TRAILS AT OVERLAND RANCH- FILING 01

SITE PLAN

SHEET TITLE:
TRACKING SHEET

SHEET TITLE:
GRADING &
UTILITY PLAN

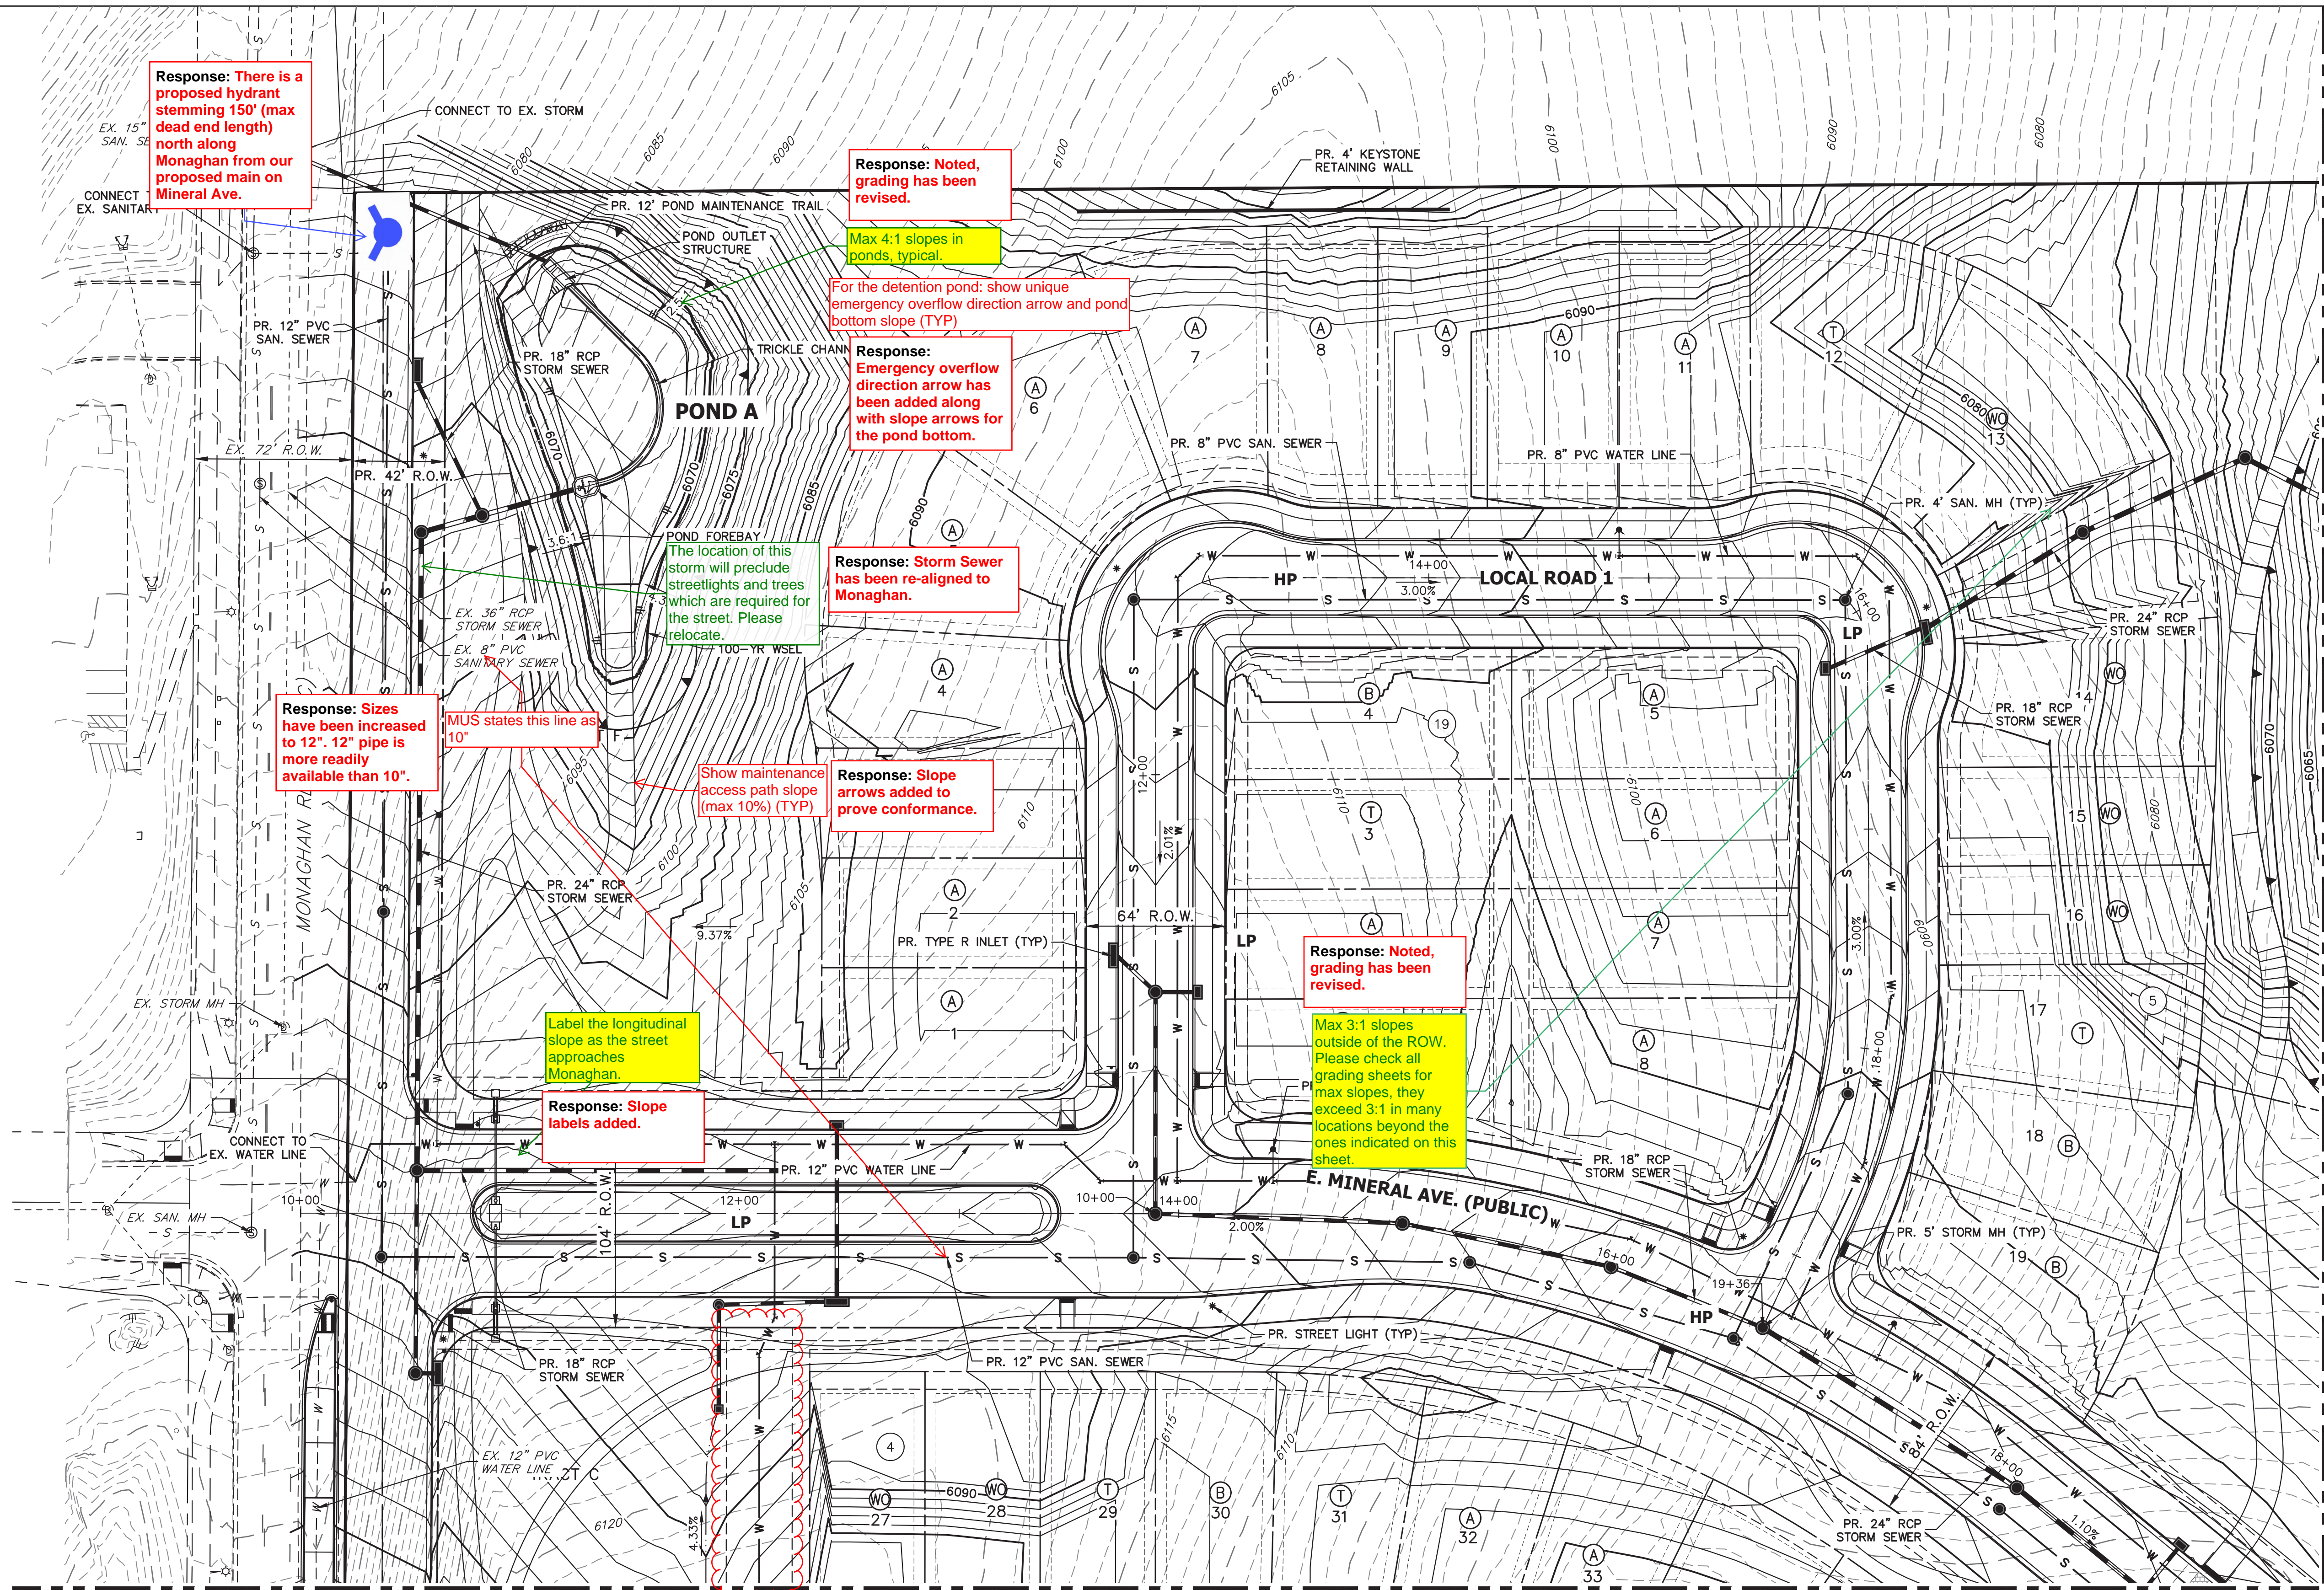
- PROPOSED STORM SEWER SYSTEM IS PUBLIC AND WILL BE MAINTAINED BY THE CITY OF AURORA.
 - ALL SANITARY AND STORM MANHOLES THAT ENCOACH ON CURBS SHALL HAVE LIDS ROTATED AWAY FROM THE CURB.
- Add a note: "Minimum slope on unpaved areas is 2%, minimum slope on asphalt is 1%, and minimum slope on concrete is 0.5%." (typical all grading sheets)
- Add a note: "The maximum slope within ROW is 4:1, the maximum slope for property outside of the ROW is 3:1." (typical all grading sheets)

Second request to provide street names for any Local Roads.

Response: Street names have been updated.

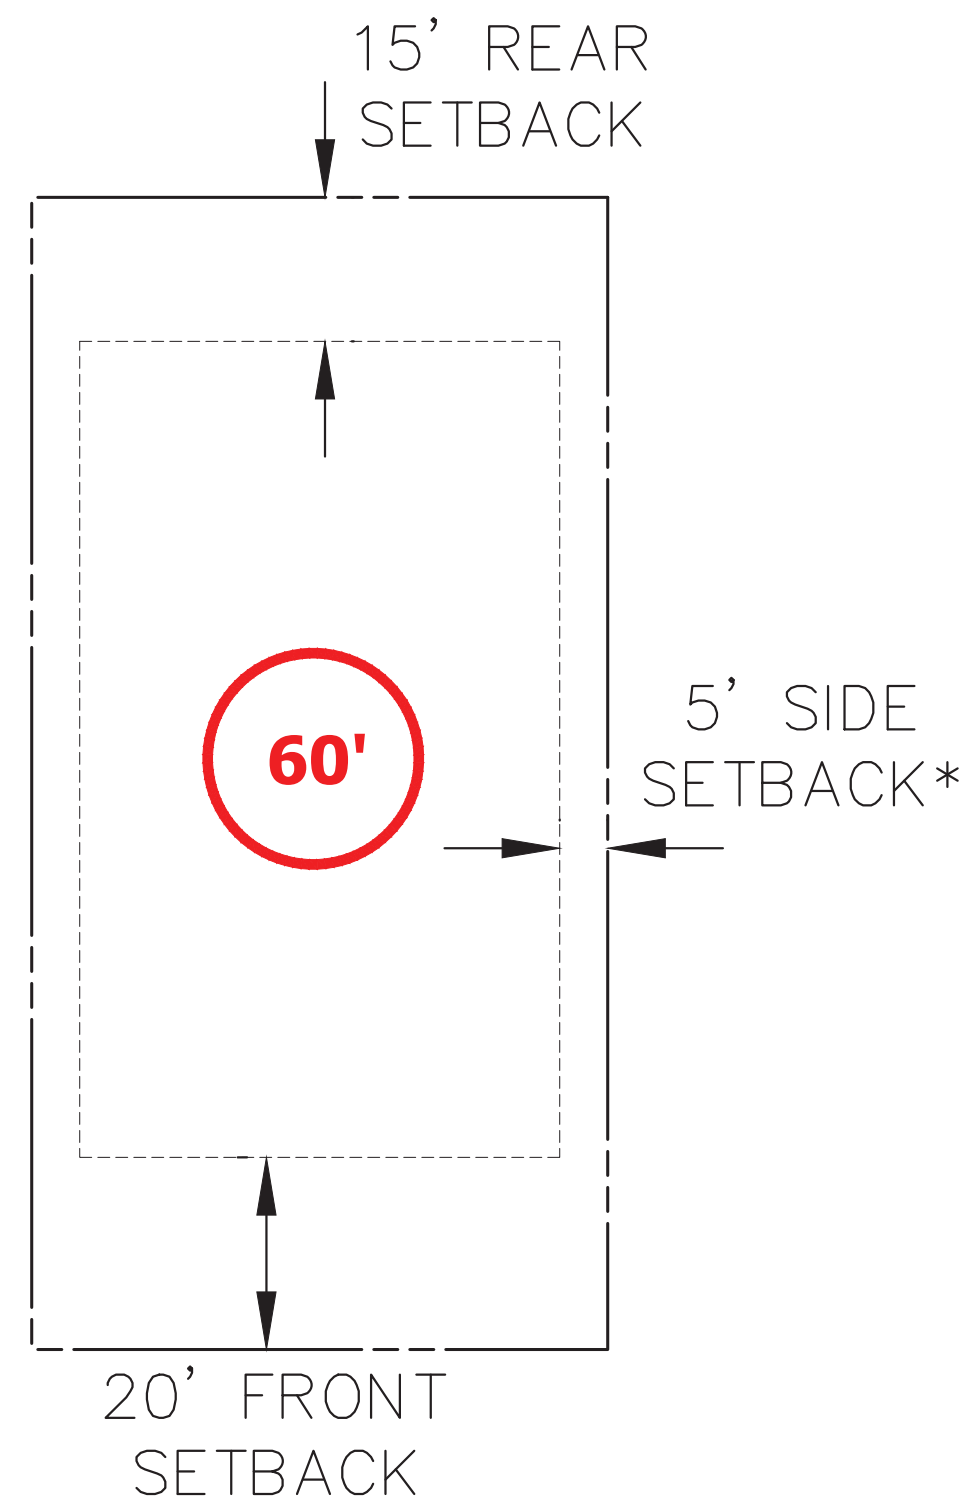
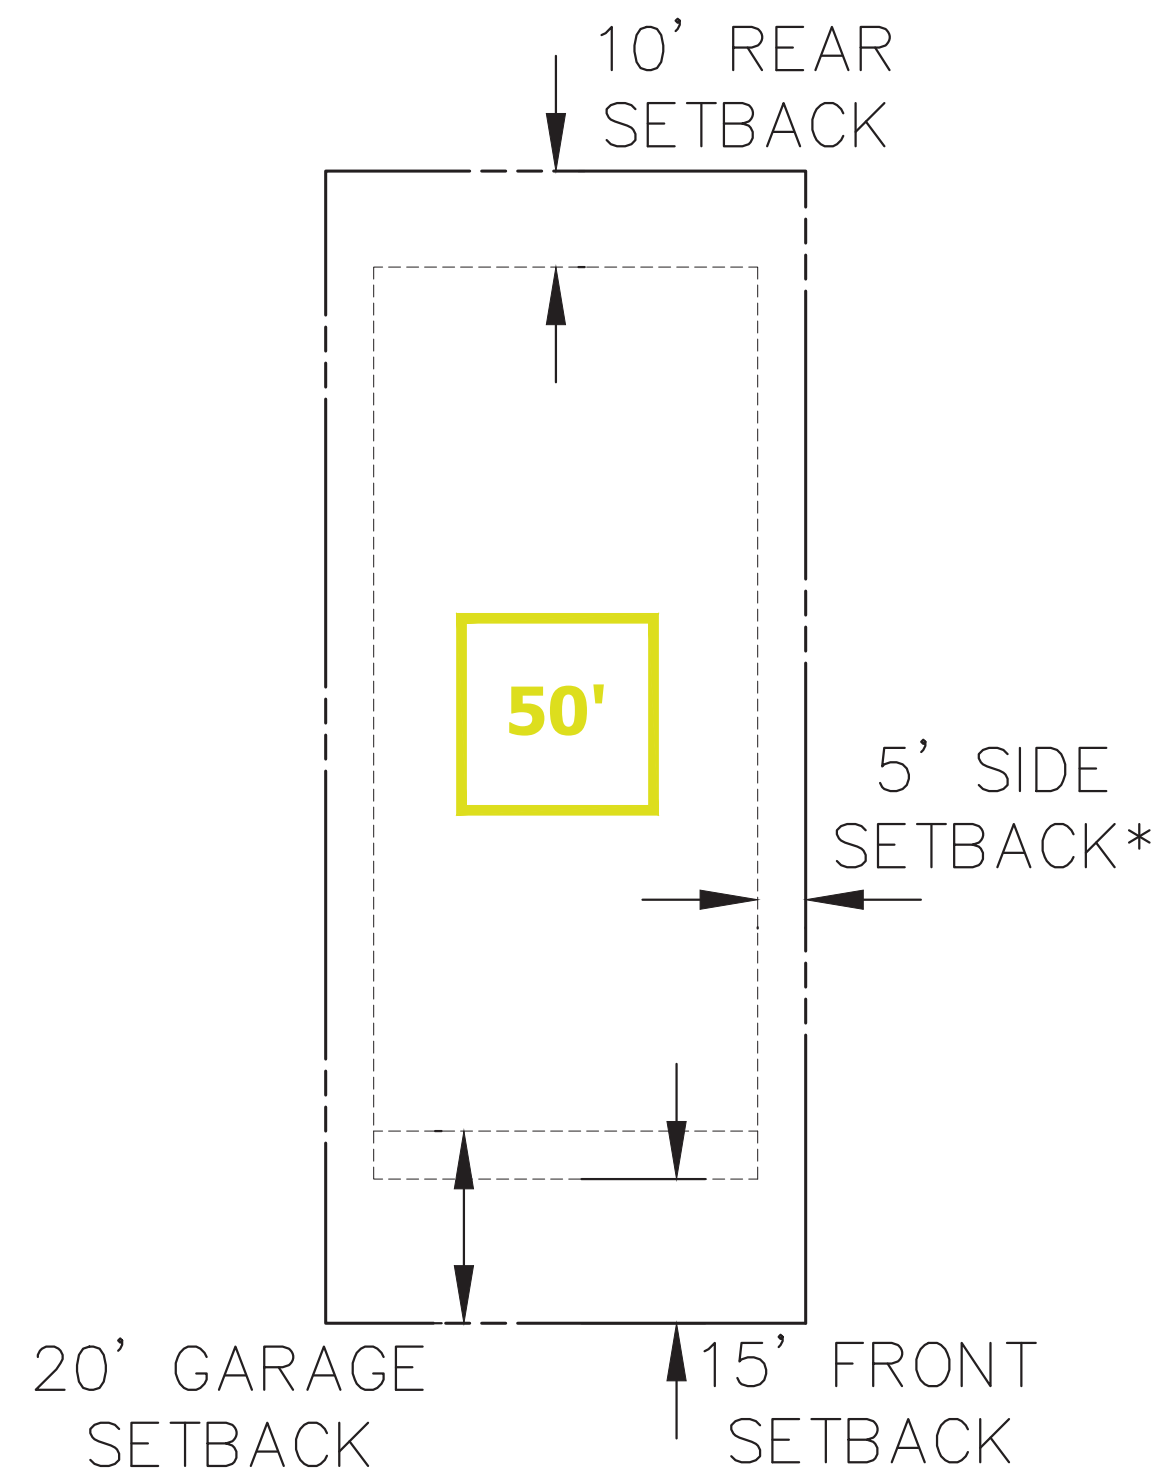
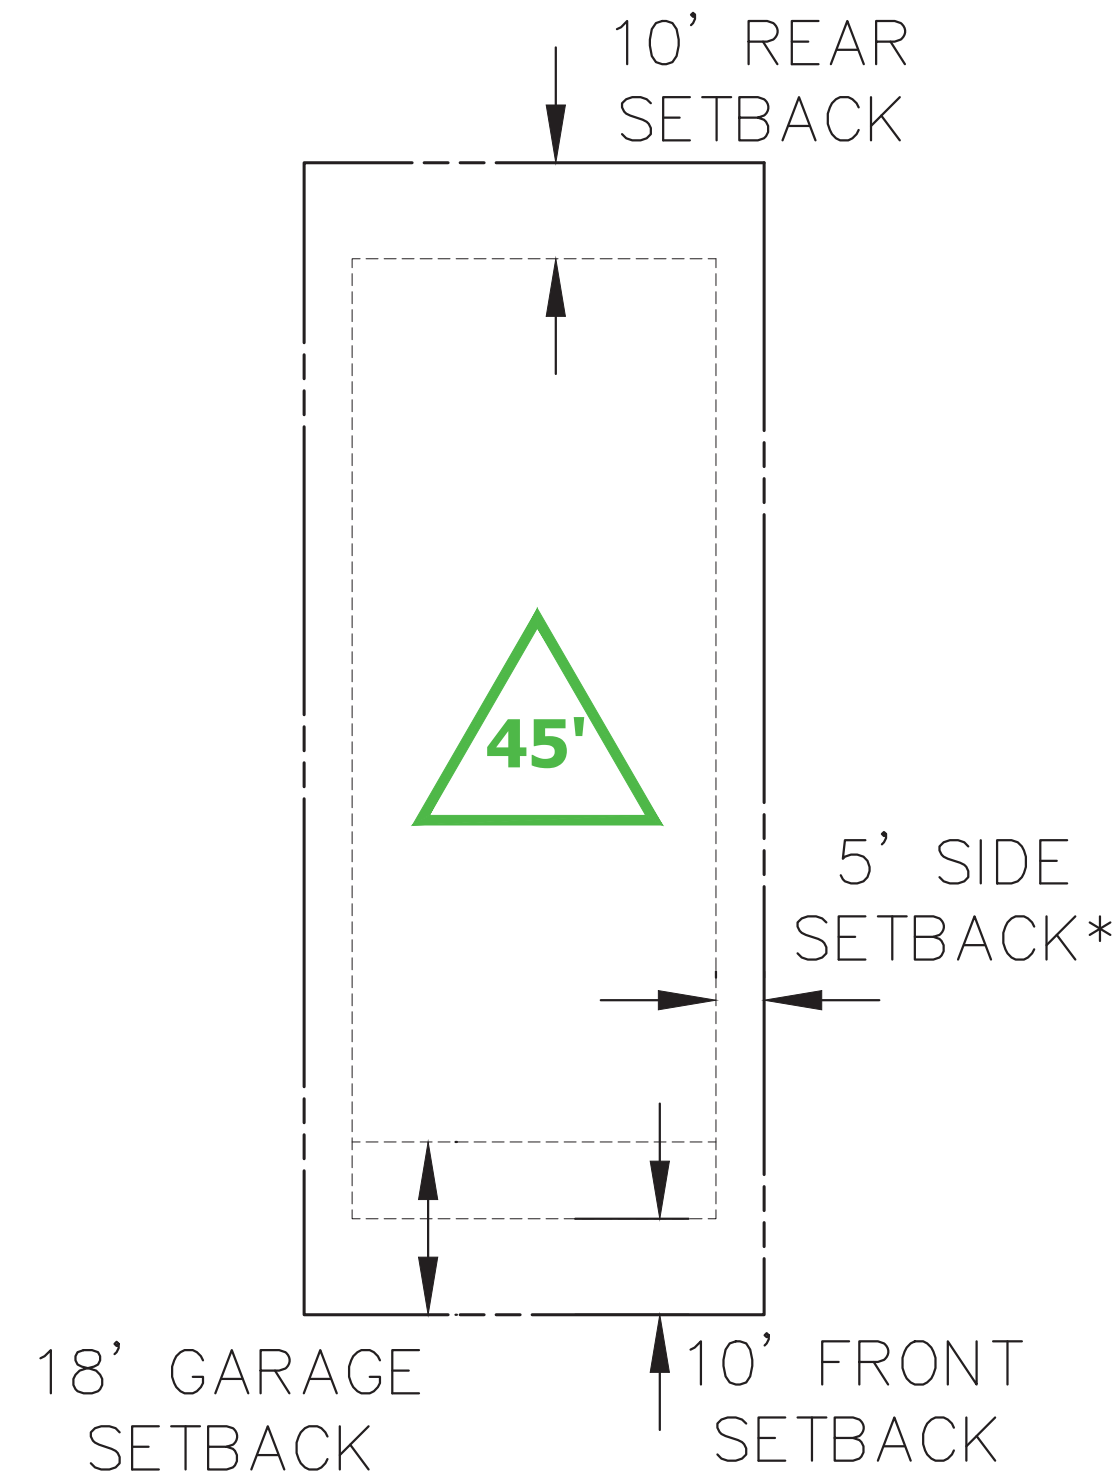
Show railing on the
wall sections, typical.

Response: Note
added stating railing
shall be added to all
walls over 30" in
height. Further detail
will be provided with
the Construction
Document Submittal.
